SUNDRY NOTICE

1. OGCC Operator Number: 96850 4. Contact Name: Howard Harris
2. Name of Operator: Williams Production RMT Company LLC
3. Address: 1001 17th St., Suite 1200 City: Denver State: CO Zip: 80202
5. API Number: OGCC Facility ID Number: Survey Plat: X
6. Well/Facility Name: Mautz Ranch Multi Well Pit 7. Well/Facility Number: Location ID 422672 Directional Survey: X
8. Location (Qtr/Tr, Sec, Twp, Rng, Meridian): SENW Sec 19 T2S-R98W Surface Eqpmt Diagram:
9. County: Rio Blanco 10. Field Name: Sulphur Creek Technical Info Page: X
11. Federal, Indian or State Lease Number: Other:

- 1. OGCC Operator Number: 96850 API Number: _____
- 2. Name of Operator: Williams Production RMT Company LLC OGCC Facility ID # _____
- 3. Well/Facility Name: Mautz Ranch Multi Well Pit Well/Facility Number: _____ Location ID 422672
- 4. Location (QtrQtr, Sec, Twp, Rng, Meridian): SENW Sec 19 T2S-R98W

Mautz Ranch - Multi Well Pit
CONSTRUCTION LAYOUT

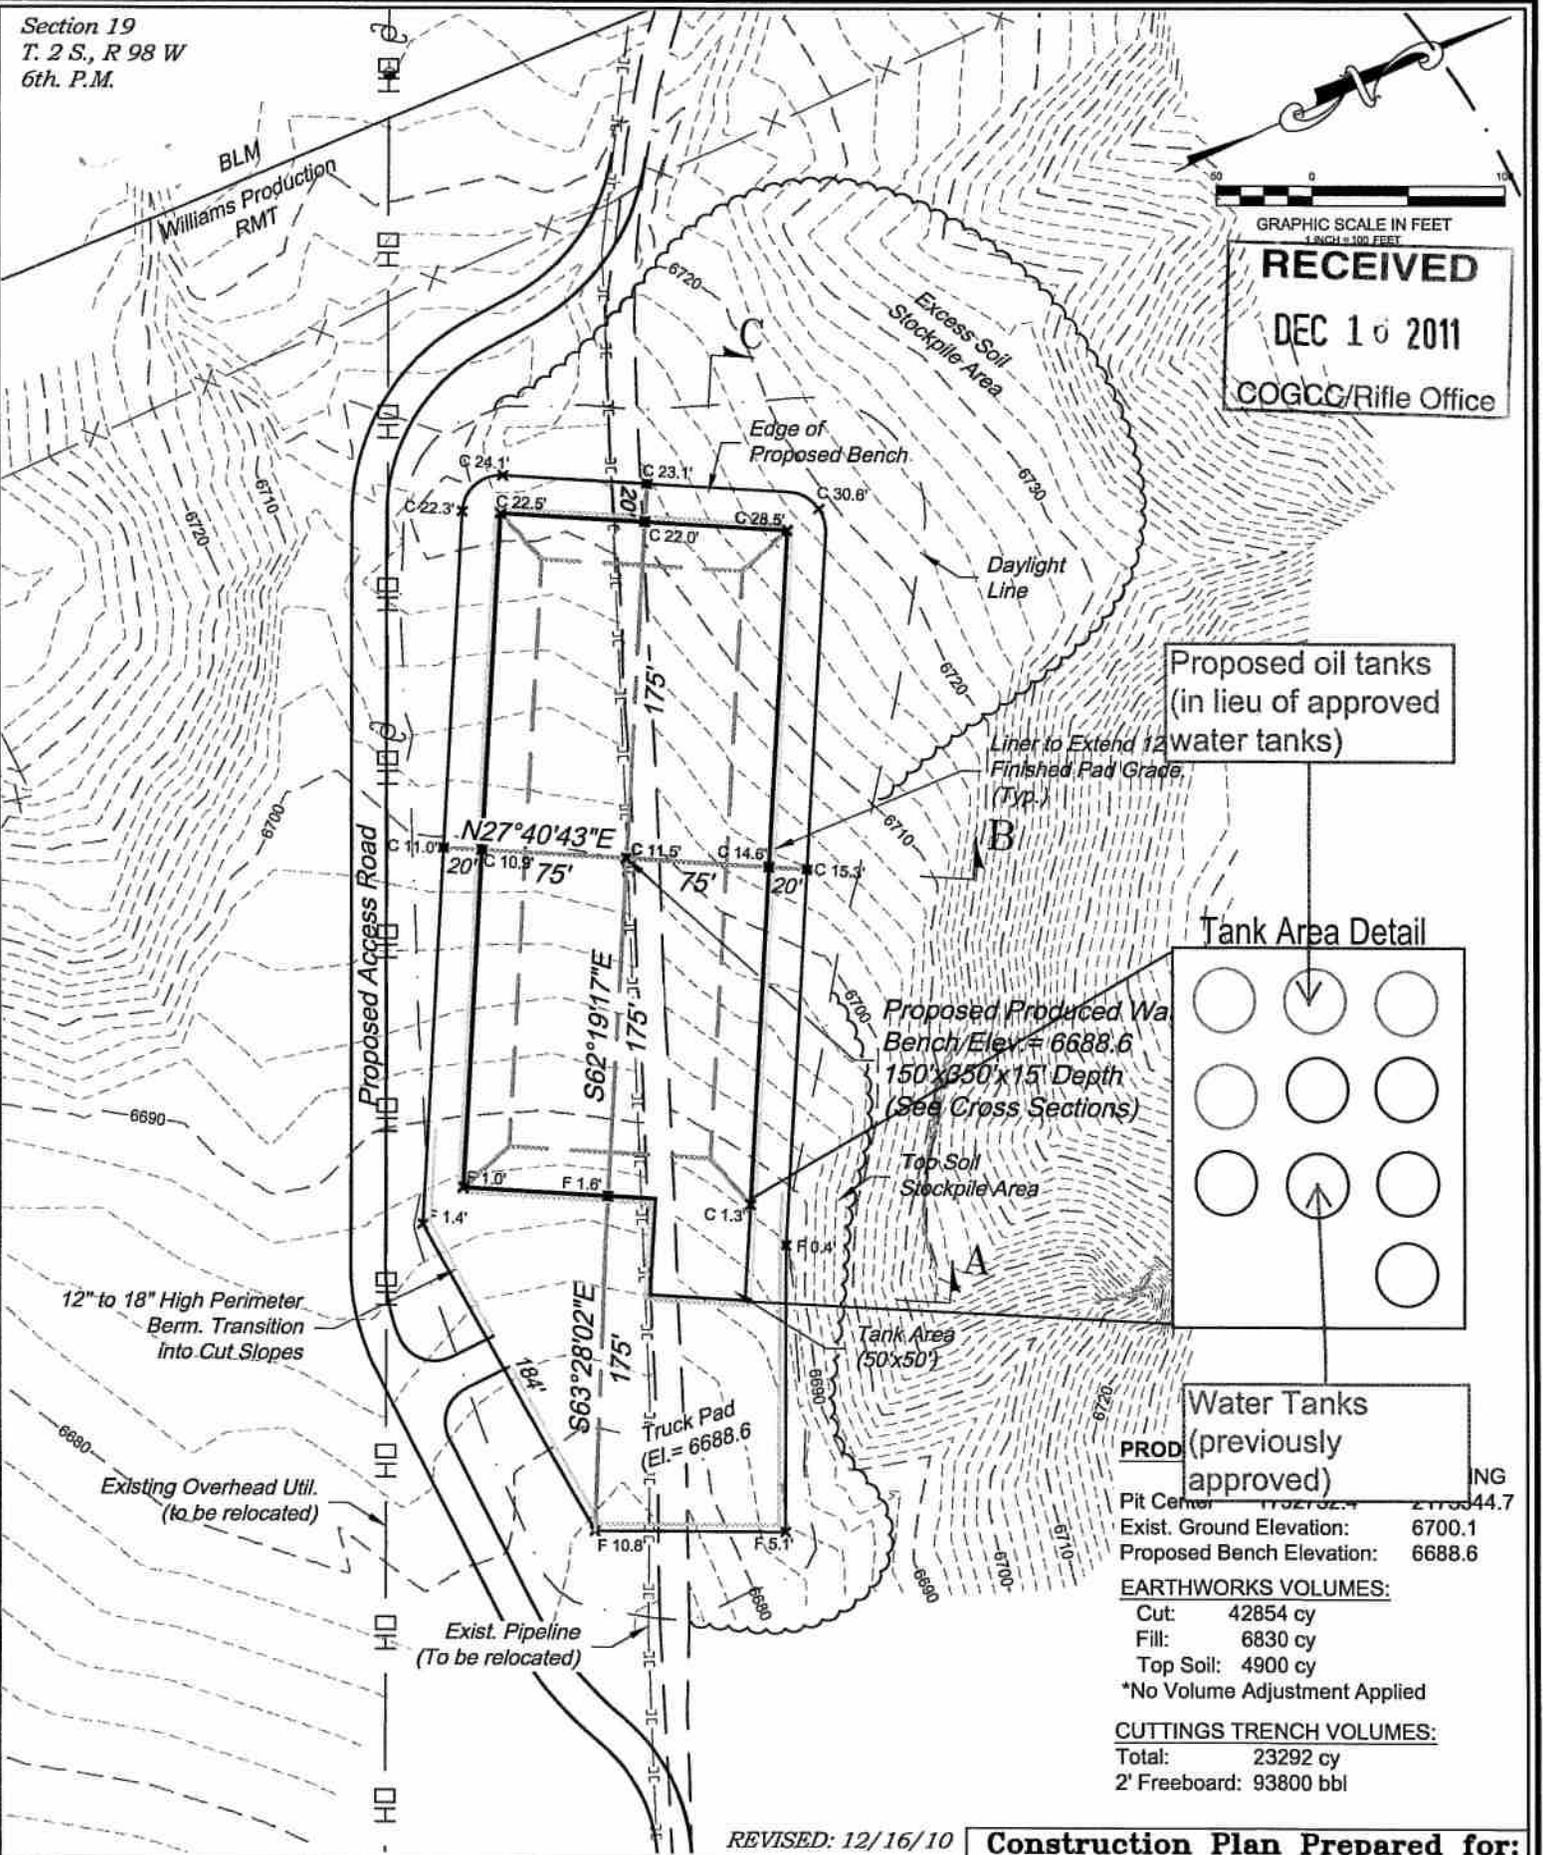
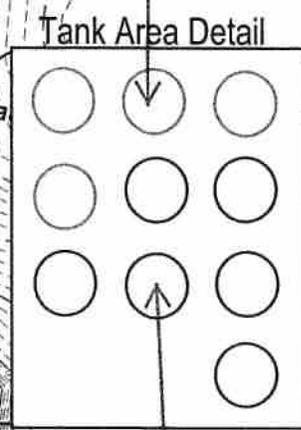
Williams requests authorization to replace 4 of the previously approved 10 water tanks with condensate tanks. These tanks will be used to hold pit skim recovered from the adjacent approved Multi-Well Pit until oil can be sold. Proposed condensate tanks will be located in the previously approved tank battery (see attached drawing – refer to 50 x 50' Tank Area and Detail.

The proposed tank battery will house 6 water tanks and 4 condensate tanks. Construction will begin upon COGCC approval. No additional disturbance will result from this request.

Proposed oil tanks
(in lieu of approved
water tanks)

Water Tanks
(previously
approved)
